SPRINGBANK OFF-STREAM RESERVOIR PROJECT

**BOOK OF DOCUMENTS OF ALBERTA TRANSPORTATION
TO THE REPLY SUBMISSIONS OF ALBERTA TRANSPORTATION TO
THE INTERVENERS AND HEARING PARTICIPANTS WHO ARE
OPPOSED TO THE SPRINGBANK OFF-STREAM RESERVOIR
PROJECT (“SR1”)**

**Technical memorandum prepared by Stantec in response to the
Austin Engineering Report**

Reference: Response to Mr. Ian Dowsett Submission from SCLG

Figure 1

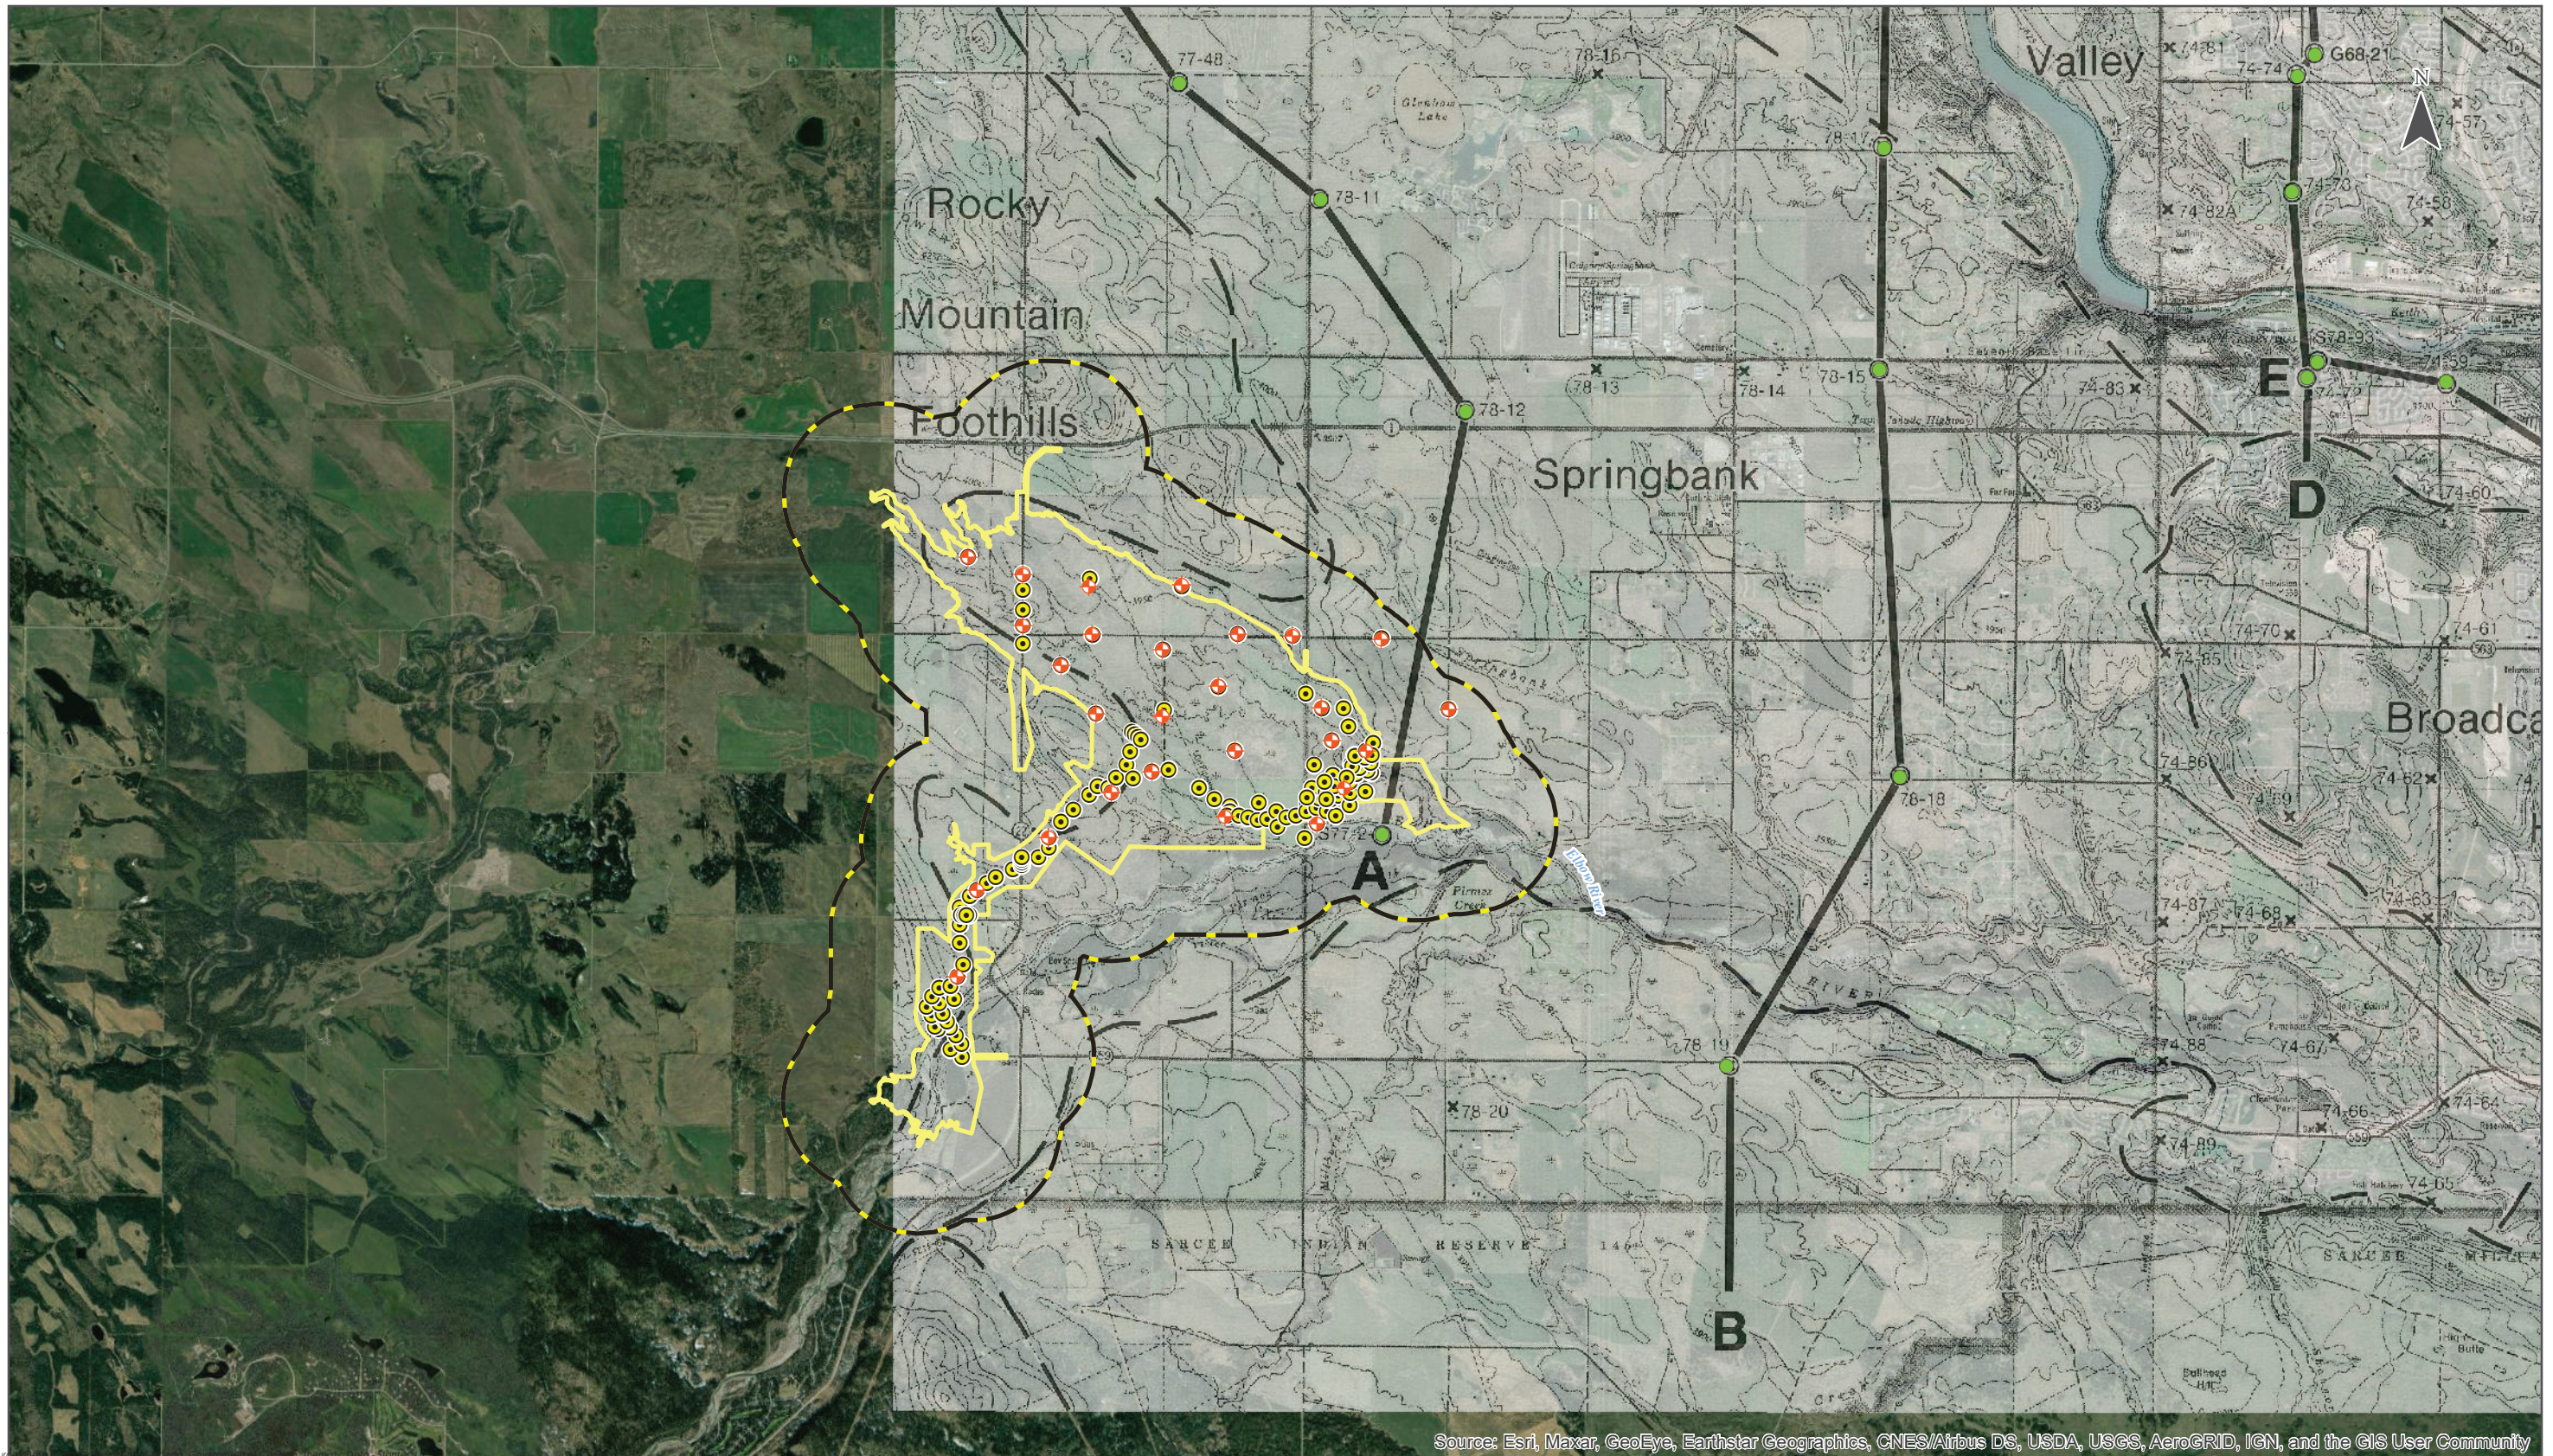
On page 5 of Dr. Fennell's report, he presents as Figure 1 a geologic cross section (B-B') adopted from Moran (1986) which he asserts is representative of conditions in the SR1 Project area. The Moran (1986) report is a regional scale study of the greater Calgary area, and while informative of the regional geologic context, is not suitable for use in support of a local scale assessment of geologic conditions in the SR1 Project area. In particular, the geologic cross section that Dr. Fennell presents as evidence of the local

Figure 1 herein presents the location of cross section B-B' and the borehole locations from which it is informed, relative to the SR1 PDA. It should be noted that cross section B-B' presented in the Moran (1986) report and cited by Dr. Fennell is situated east of the PDA and is informed by only a small number of boreholes spaced kilometres apart from each other. It is also unclear why cross section A-A' from the same Moran (1986) report, which is situated closer to the PDA than cross section B-B', was not presented. Cross section A-A', while being similarly limited by data paucity, does not indicate the presence of the surficial fluvial gravel (unit Gg) or fluvial channel sand (unit Cs) which were interpreted to exist along cross section B-B', and is more consistent with the hydrogeologic framework of the PDA as has been summarized in the Hydrogeology Technical Data Report Update (Exhibit 110). Figure 5 from the Moran (1986) further confirms that the surficial fluvial gravel (unit Gg) is not present in the SR1 PDA.
